**Tweed Shire Council Submission - Australian Bay Lobster Producers (ABLP)
DA 282-11-2004-i Mod 4**

I refer to the recent exhibition of the proposed modification of DA 282-11-2004-I Mod 4 for the Australian Bay Lobster Facility at Lot 1 DP 1192506, 9484 Tweed Valley Way, Chinderah. Council officers have undertaken a review of the proposal and provide the following comments for the Department's consideration.

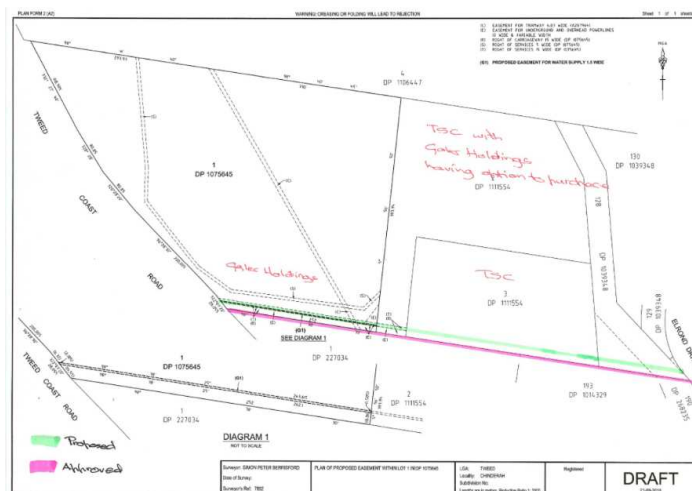
The proponent makes reference to having consulted with TSC and makes reference to an email from January 2019, whereby an agreement in principle was obtained from Council for the extraction of seawater from the Tweed River adjacent to JEBH, in the event that an agreement with SEQ Water could not be obtained for water extraction at the desalination plant.

It should be noted that the 'urgent and critical' request from ABLP for access to seawater over a four week period made no reference to any significant increase in extraction limits, nor 24/7 operations. As noted in Council's email of 21 January 2019, the temporary extraction of seawater was based on further detail being provided and relevant consent being obtained from the Department, with Council needing to further consider any longer term proposal.

The abovementioned request for emergency extraction of seawater from JEBH is not considered to be adequate consultation with Council, particularly with regard to all aspects of Mod 4.

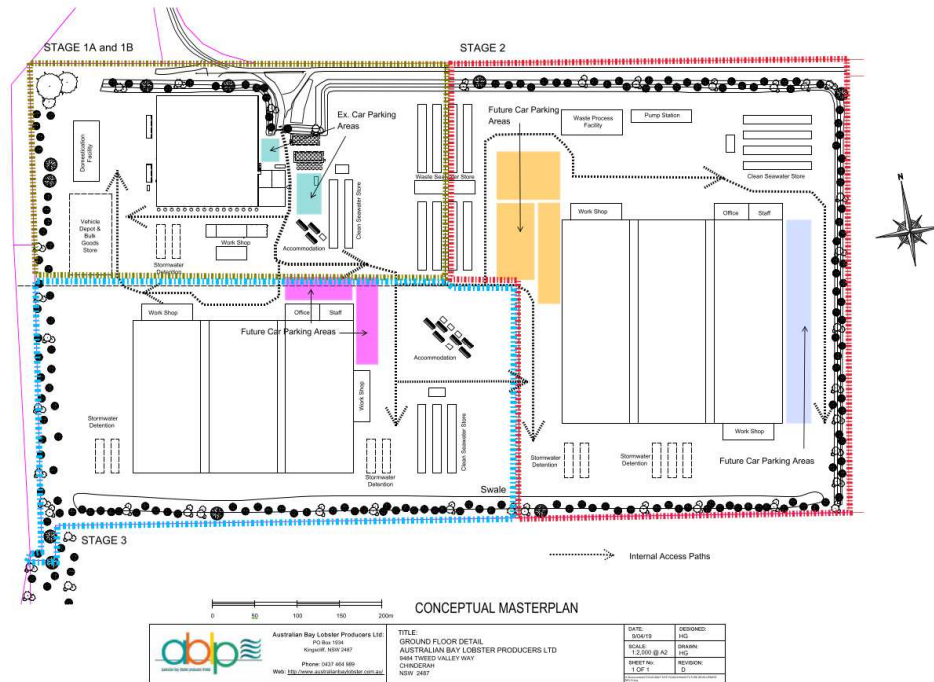
Council and Gales Holdings have been in negotiations with ABLP in terms of the proposed realignment of the pipeline over the three allotments shown above. It is noted that an easement between 8m and 9.5m from the southern boundary of all three allotments is required.

Should the proposed modification be granted approval, it is recommended that the following new condition be applied:

The proposed seawater intake pipeline shall have a minimum separation distance of one meter from the collar of the trunk water main and/ or sewer rising main.
